ADDENDUM NO. 2

SIGNATURE/
BLOCK:
 PROJECT TITLE:
RESURFACING, BRIDGE AND SAFETY IMPROVEMENTS ON ROUTE 2

PROJECT NO.
42-317
 DRAWING NO.
S-33
 SHEET NO.
05.34.A2

SHEAR CONNECTOR DETAILS

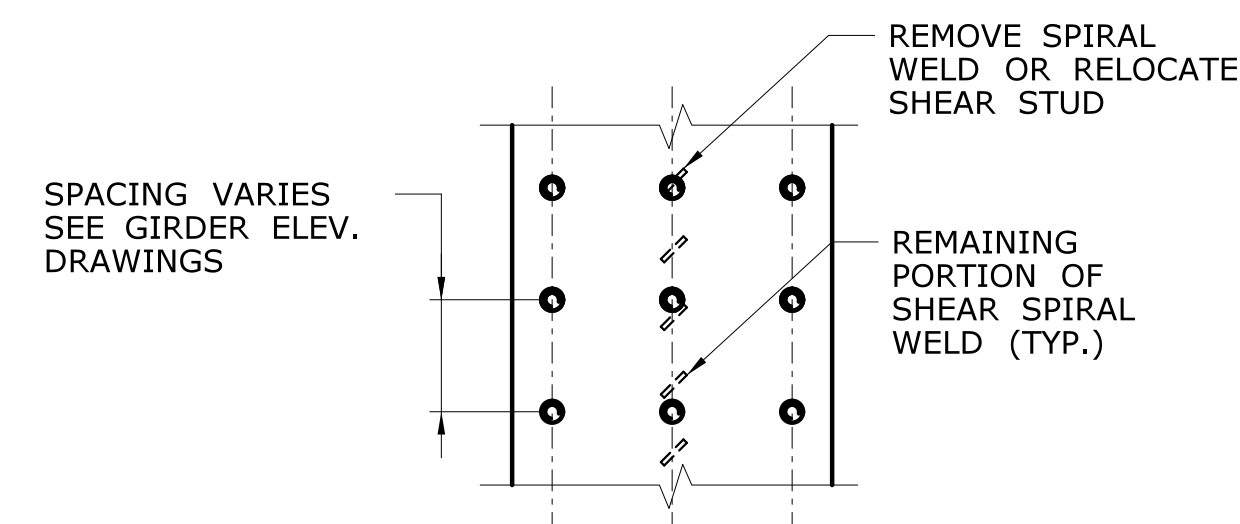
12.18.20	PAY ITEM NOTE	05.34.A2	
DESIGNED BY: CDW SMITH 77 HARTLAND STREET SUITE 201 EAST HARTFORD, CT 06108			
THE INFORMATION, INCLUDING ESTIMATED QUANTITIES OF WORK, SHOWN ON THESE SHEETS IS BASED ON LIMITED INVESTIGATIONS BY THE STATE AND IS IN NO WAY WARRANTED TO INDICATE THE CONDITIONS OF ACTUAL QUANTITIES OF WORK WHICH WILL BE REQUIRED.			
REV.	DATE	REVISION DESCRIPTION	SHEET NO.
			Plotted Date: 12/18/2020
